METFORD MEDICAL

ARCHITECTURAL DRAWING SCHEDULE

ISSUE FOR DA

REVISION 2 UPDATES (01/12/23)

DRAWING : PROPOSED SITE PLAN & ANALYSIS

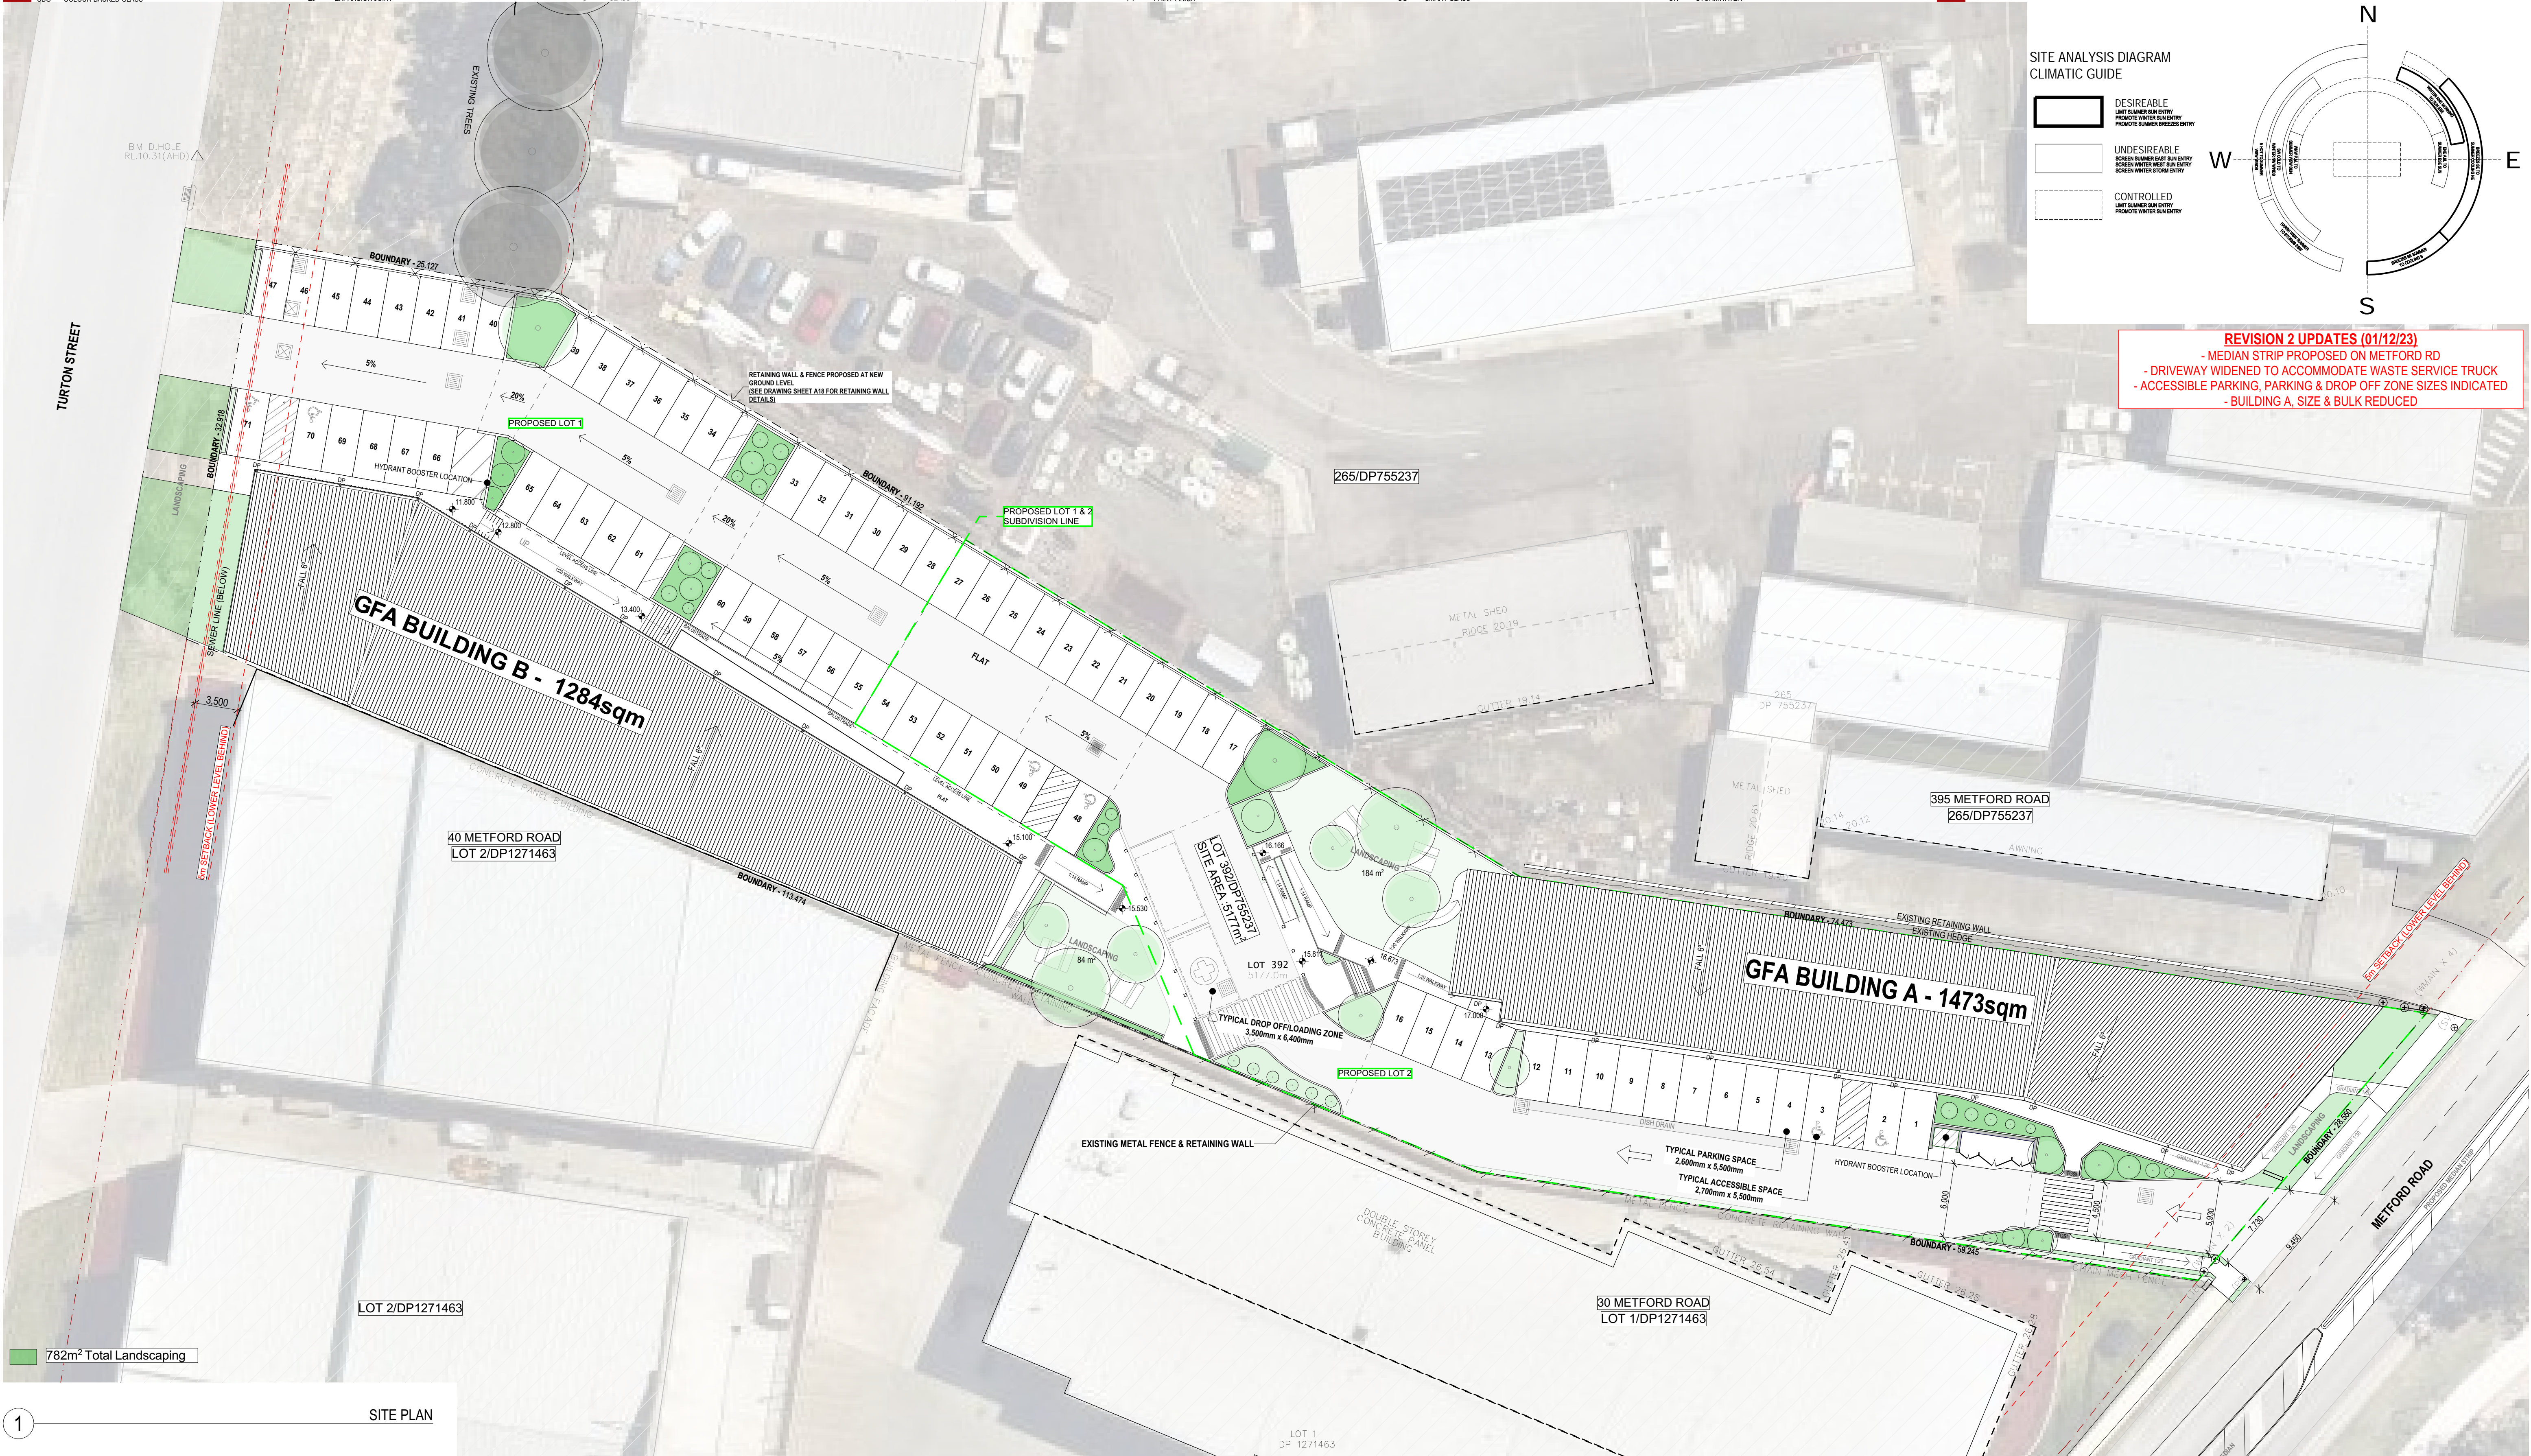
- MEDIAN STRIP PROPOSED ON METFORD RD
- DRIVEWAY WIDENED TO ACCOMMODATE WASTE SERVICE TRUCK
- ACCESSIBLE PARKING, PARKING & DROP OFF ZONE SIZES INDICATED
- BUILDING A, SIZE & BULK REDUCED

SITE : 412 KING STREET, NEWCASTLE,
NSW 2300
DRAWING : BUILDING A - SECTION A-A, B-B, C-C, D-D

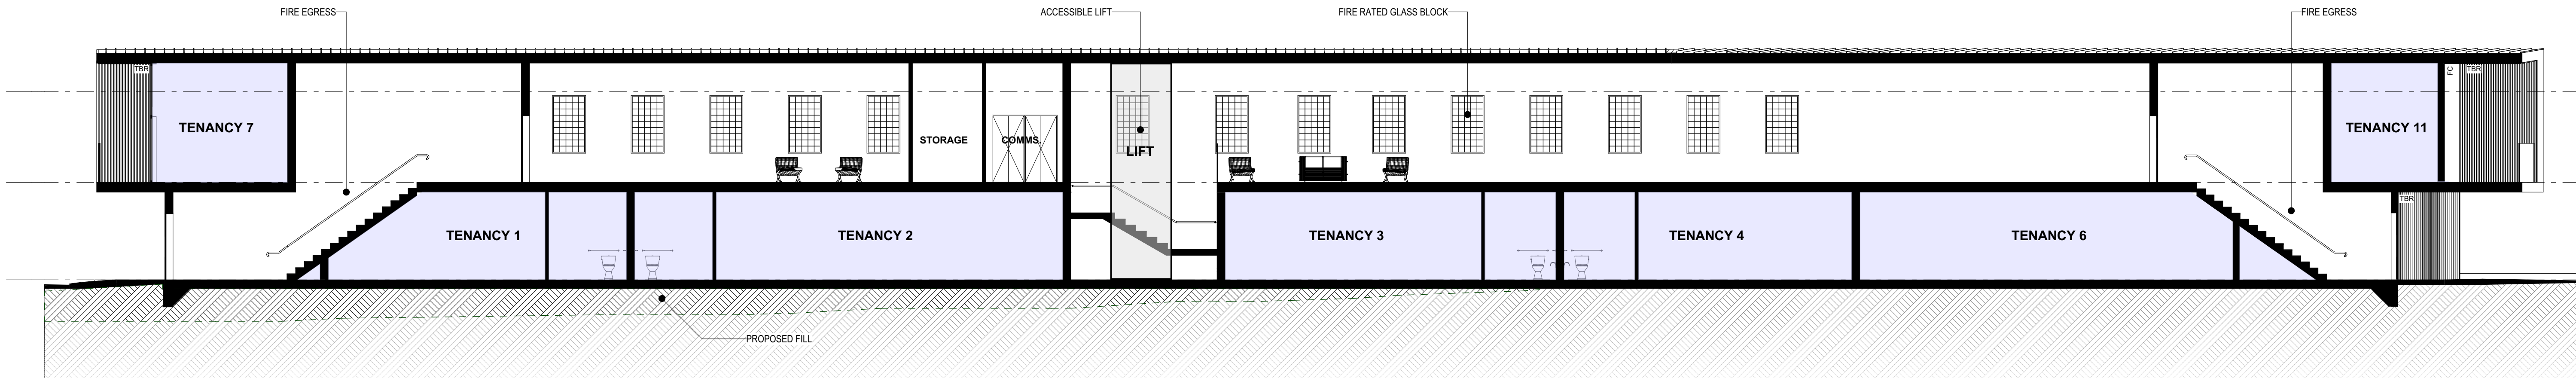
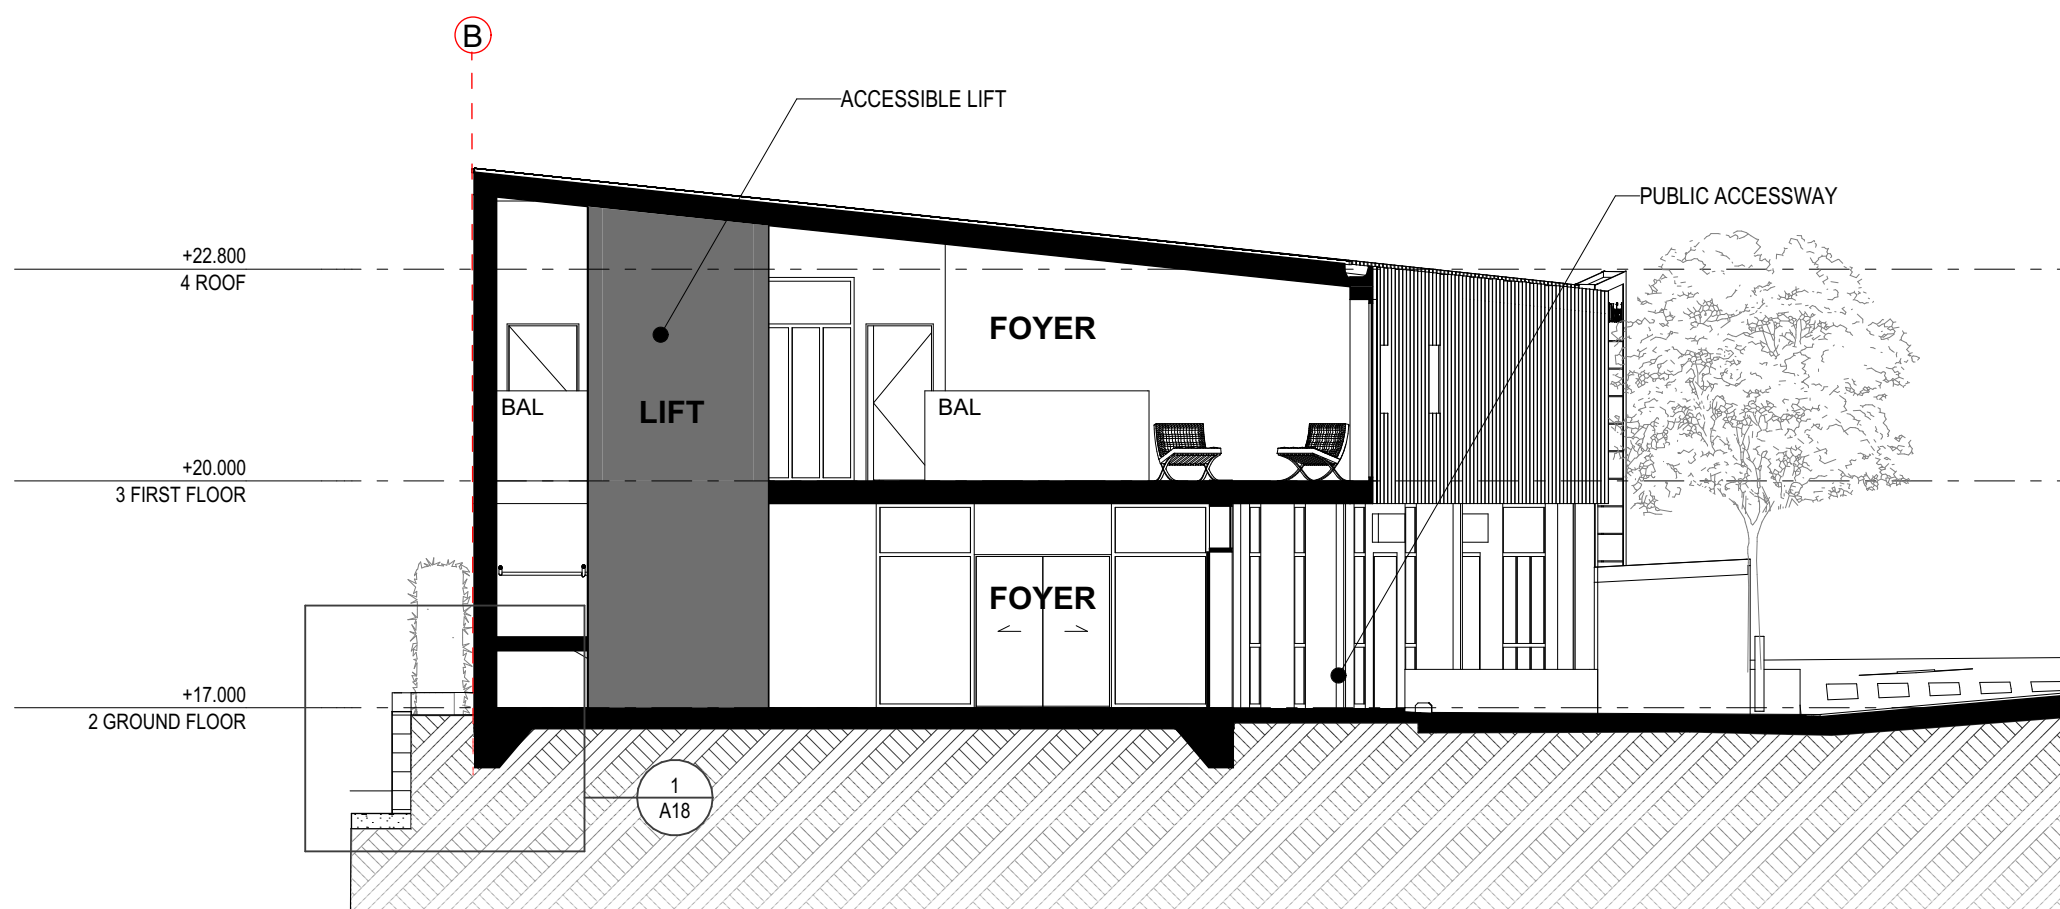
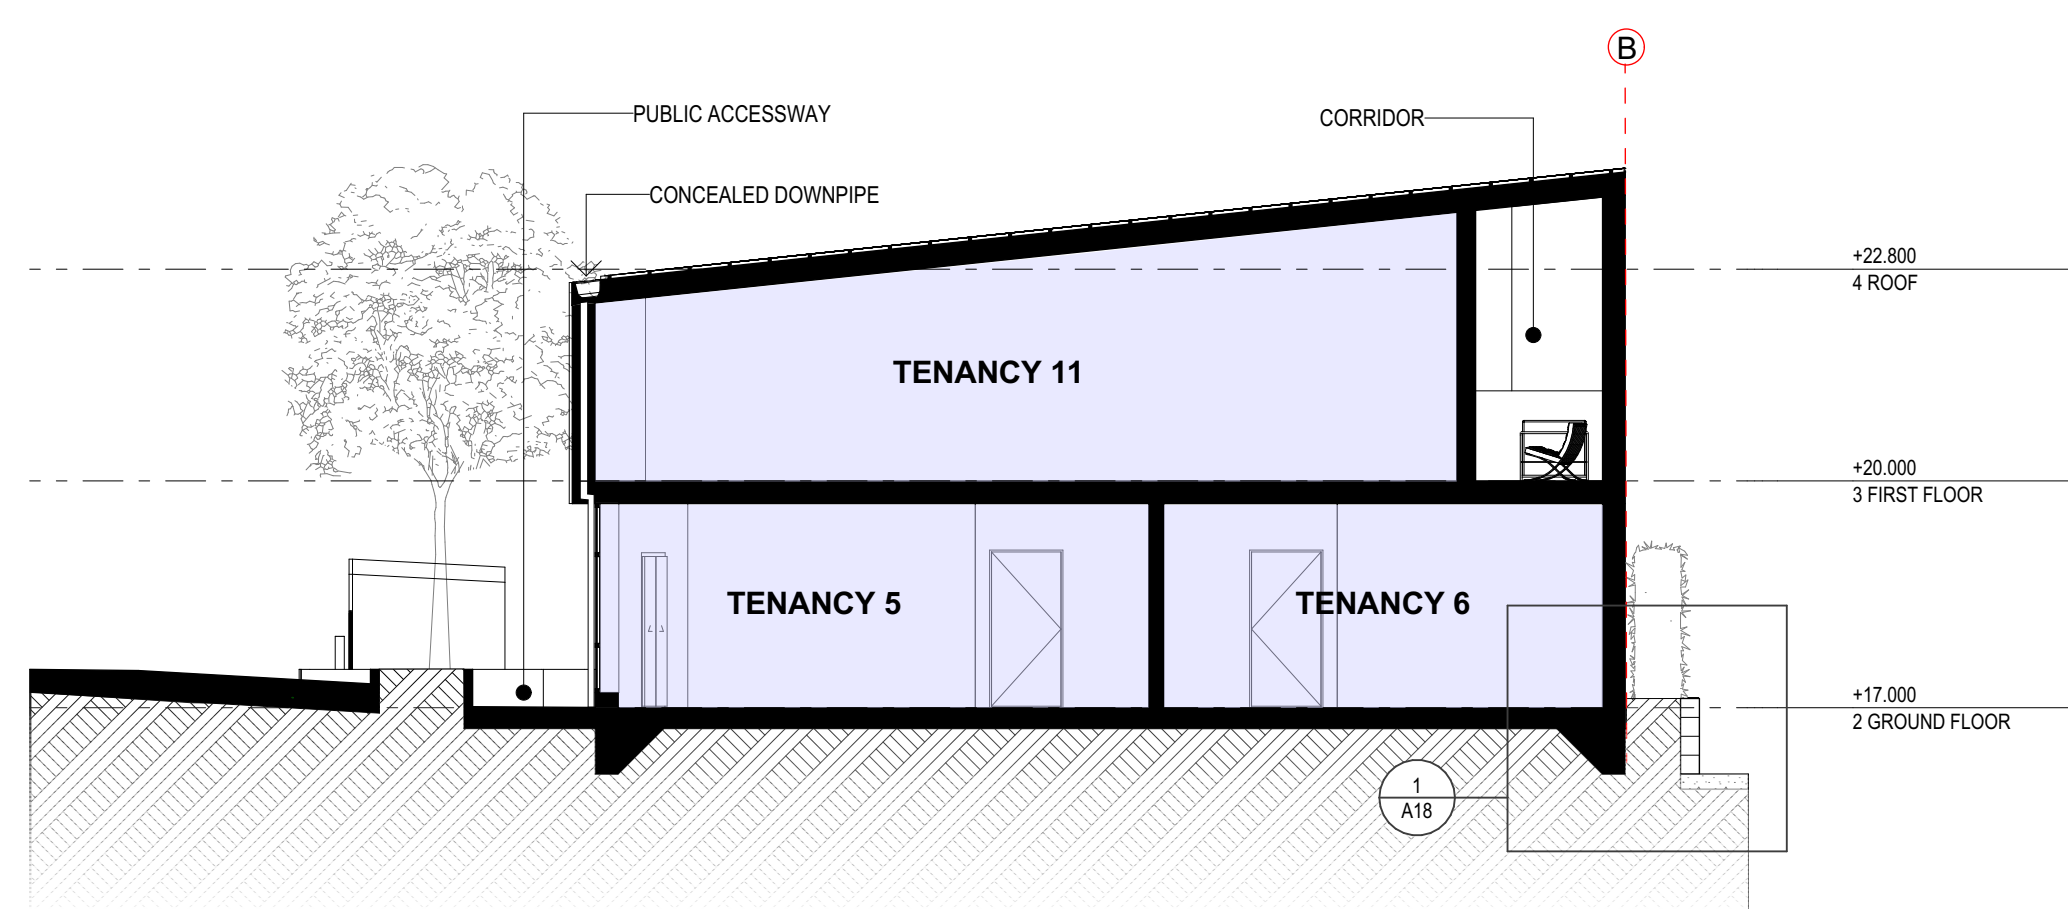
REVISION 2 UPDATES (01/12/23)
- BUILDING A STREET FRONTAGE BULK REDUCED
